Groundwater Application Review Summary Form

Application # G- 18383

PUBLIC INTEREST REVIEW FOR GROUNDWATER APPLICATIONS

TO: Water Rights Section Date 05/05/2017
 FROM: Groundwater Section Dennis Orłowski
Reviewer's Name
 SUBJECT: Application G- 18383 Supersedes review of _____
Date of Review(s)

Water-Level Trends in Nearby Wells – Static, Year-round

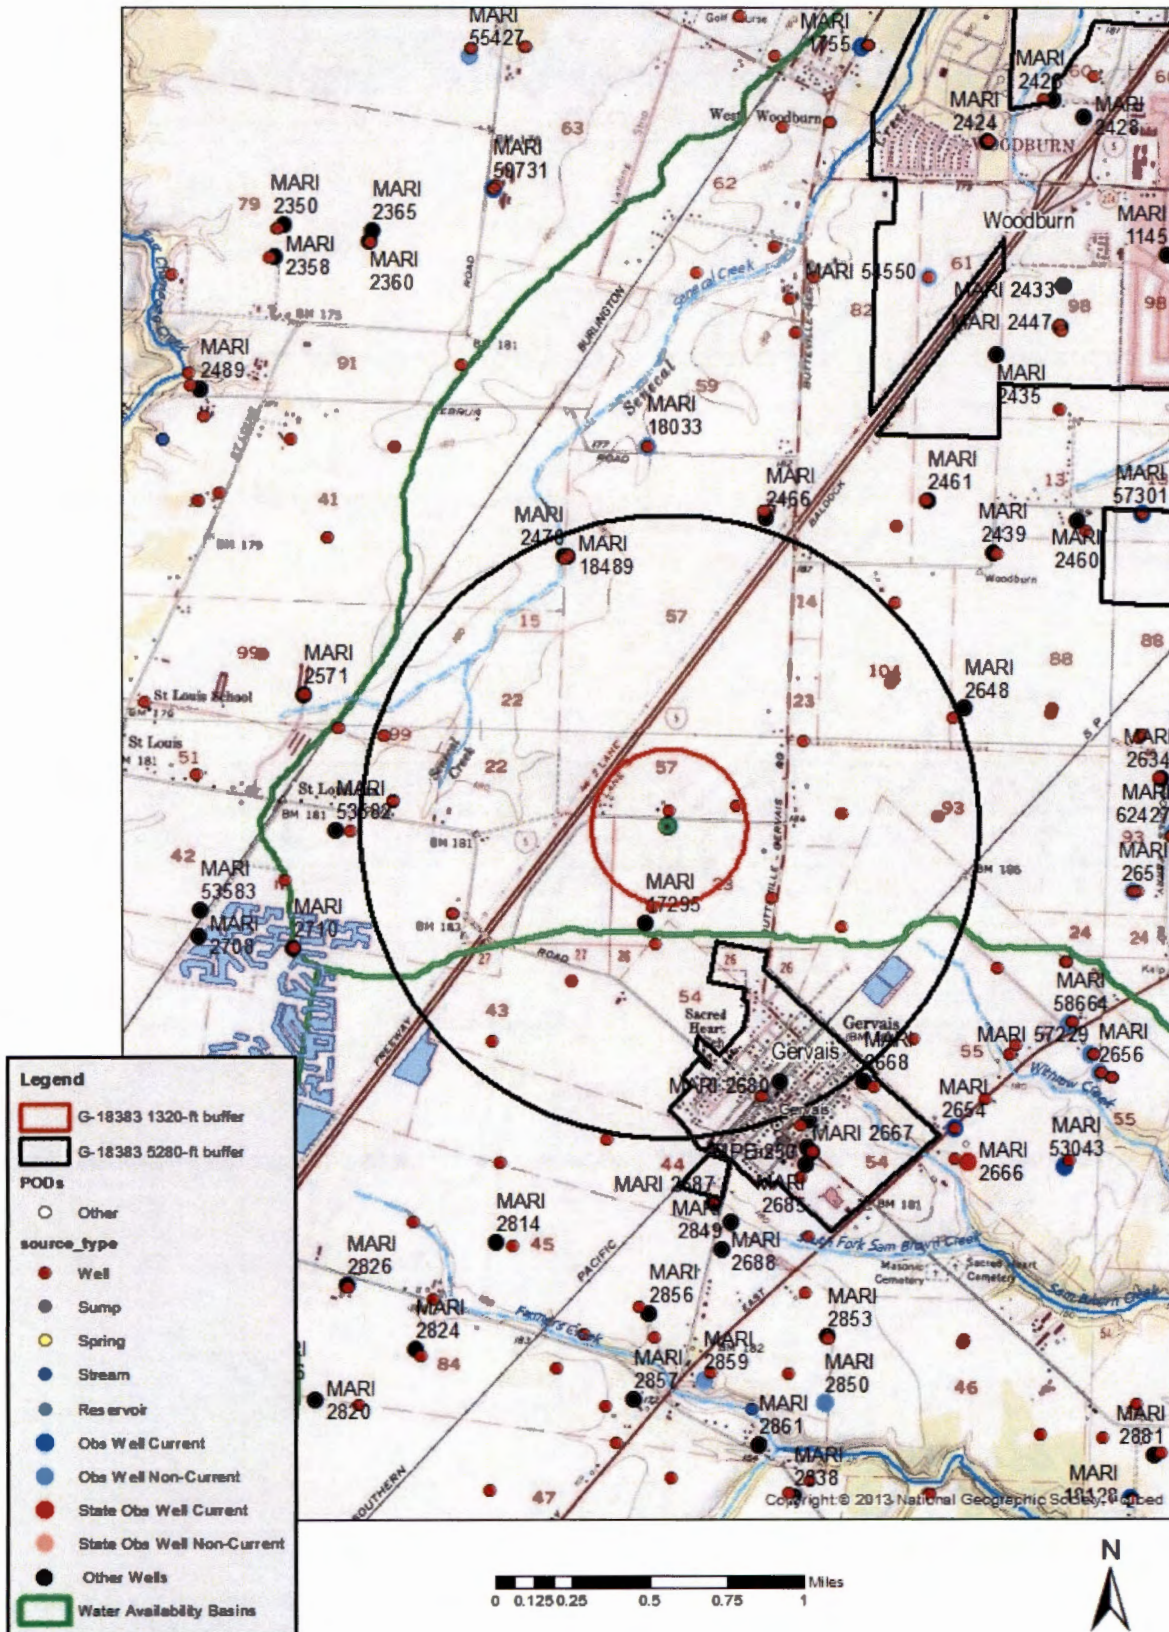
Water level data available from nearby alluvial aquifer wells show fairly stable trends over the past 12-15 years (see attached hydrograph). However, seasonally these levels can fluctuate from 25-40 feet.

Due to the nearby POA (MARI 2624) and possibly other exempt wells, the relatively-high requested allocation, and the large seasonal range of groundwater levels, the permit conditions noted in B1 and B2 are recommended.

Well Location Map

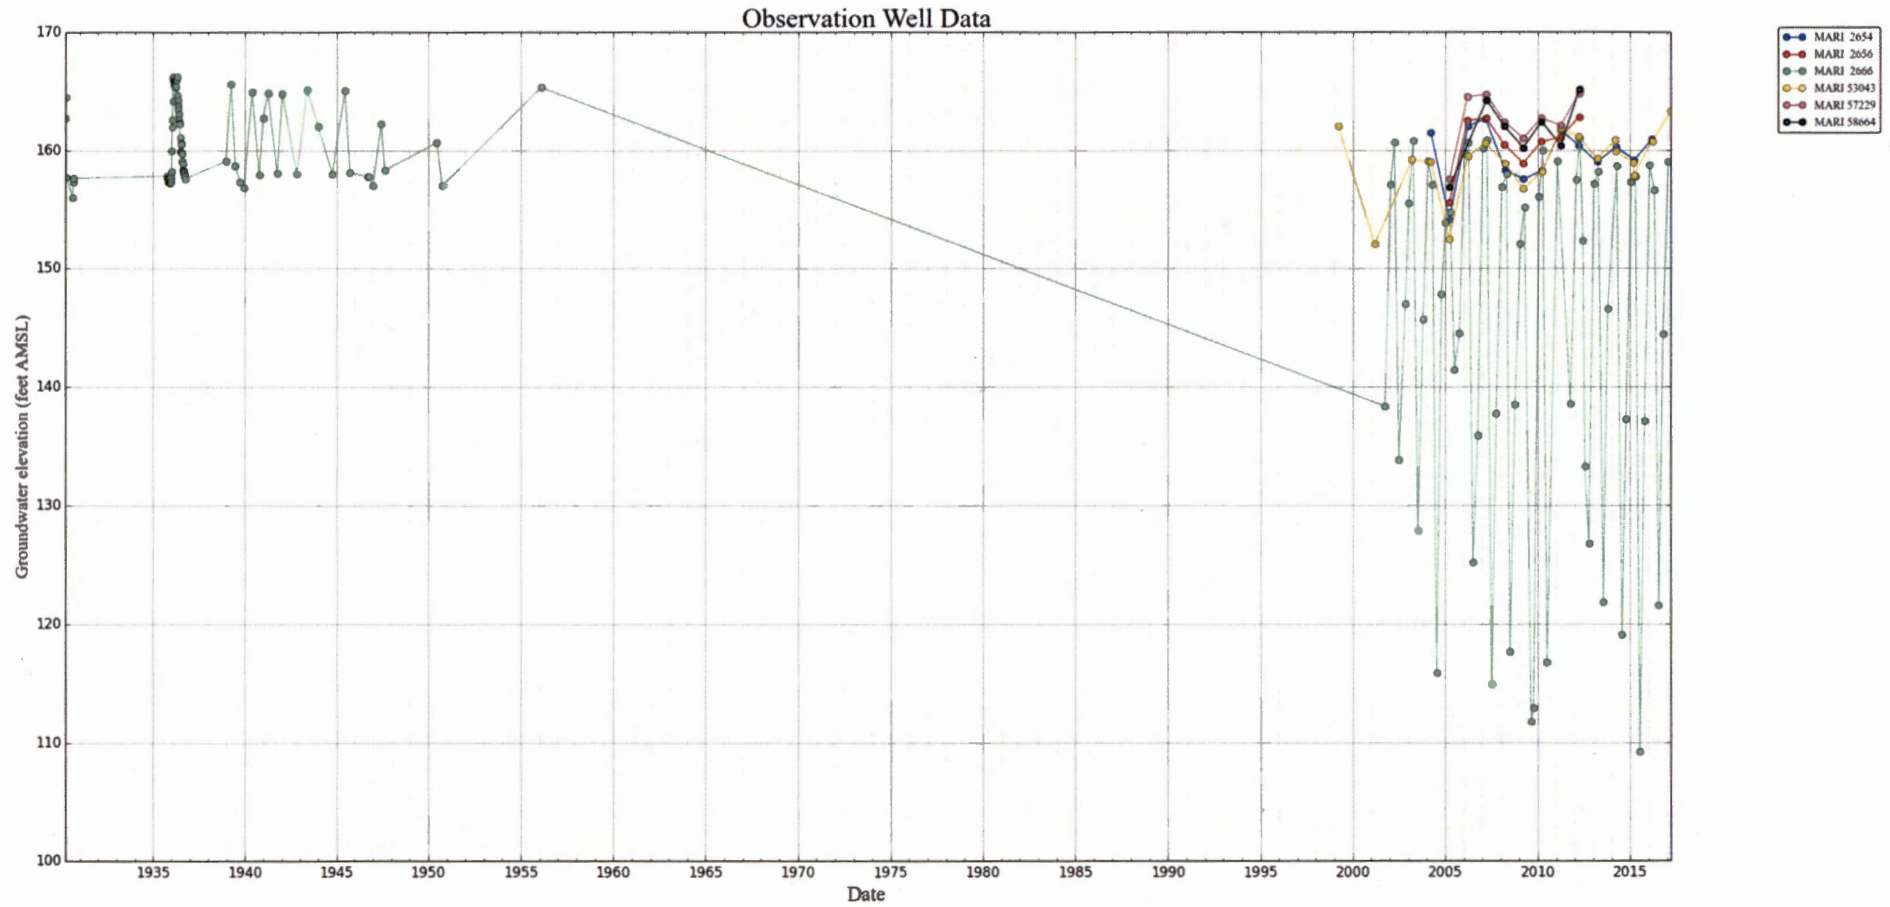
A4. **Comments:** The proposed Well 1 location is within the French Prairie region approximately 1 mile NNW of Gervais, Oregon, and about 0.3 mile due east of interstate I-5.

The land surface area near the proposed Well 1 location is quite flat. Also, several wells within ~1 mile are completed in 'sands and gravels'; most notably, existing MARI 17295 is located near the center of this application's tax lot, approximately 1650 ft south of the proposed Well 1 location (it is understood that if this application is granted, then the permit associated with MARI 17295 (permit G-11892) will be cancelled (see affidavit dated 17 August 2016 in file)).

Compared to the location of MARI 17295, the proposed location for Well 1 near the northern boundary of the application parcel will place it farther away from the town of Gervais and its relatively-high concentration of alluvial wells (including two municipal wells), thus minimizing potential interference with those wells. However, the proposed Well 1 location will be about 1200 ft away from permitted irrigation well MARI 2624 (certificate 47933), also an alluvial aquifer well.
